03-124109-DFS-01-RS

PROJECT INFORMATION		Occ. Group	Const. Type
Single Family Dwelling	Alteration	R3 U1	V-N
Project Description: REVISE FOUNDATION, SHEAR WALLS AND NOTCH A BEAM

MODIFIED BEAM AT SHEARWALL
SW CUSTER STREET, PORTLAND, OREGON
GROVE DEVELOPMENT, INC.

**SHEARWALLS GROVE DEVELOPMENT
SUPPLEMENTAL CALCULATIONS**

NOTCH PARALLAM BEAM TO FIT OVER
SIMPSON STRONG WALL

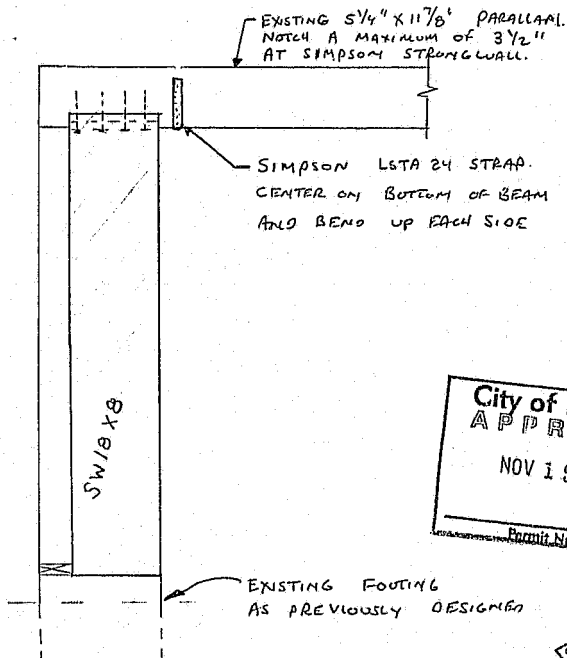
Provide design modifications for notching of Paralam Beam at interior garage wall. Due to height constraints, the beam is too low. Notch the beam a maximum of 3 1/2" at the Simpson Strong-Wall Panels. The notched beam is adequate as a reduced section for design level forces. Simpson Strong-Wall panels cantilever off of the footing as previously designed by Miller Consulting Engineers, Inc. dated 7-3-03.

EXISTING 5 1/4" X 11 7/8"
PARALLAM CAN BE NOTCHED
TO SIT ON SIMPSON STRONG
WALL PANEL. NOTCH 3 1/2"
MAX.

TYPICAL SW PANEL EACH SIDE.

REVISED FTG. SECTION

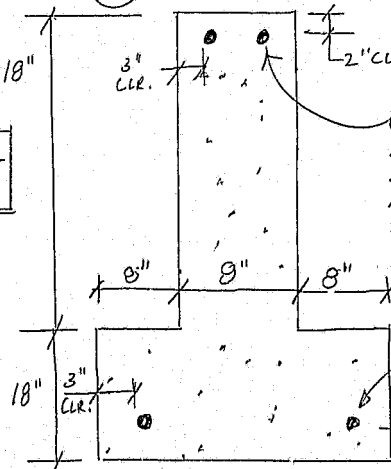
REVISED FOOTINGS FOR STEATHWALLS S1 AND R1

S1 $\Rightarrow$ SEE pg #4 of 6 of CALCULATIONS
DATED 7/3/03 (MCE JOB #030587)

USE 24" WIDE X 12" DEEP FTS. 3'-0" LAPS
WITH (2) #5 TOP 2" CLR 10" HOOK AT ENDS
WITH (2) #5 BOTTOM 3" CLR 10" HOOK AT ENDS

(2) #5 AT TOP
MIN 4'-0" LAPS
AT SPLICES.
MIN 10" VERT HOOKS AT
FTG. END.

(2) #5 AT
BOTTOM MIN
3'-0" LAPS AT
SPLICES.
MIN 10"
VERTICAL
HOOKS AT FTG.
END.
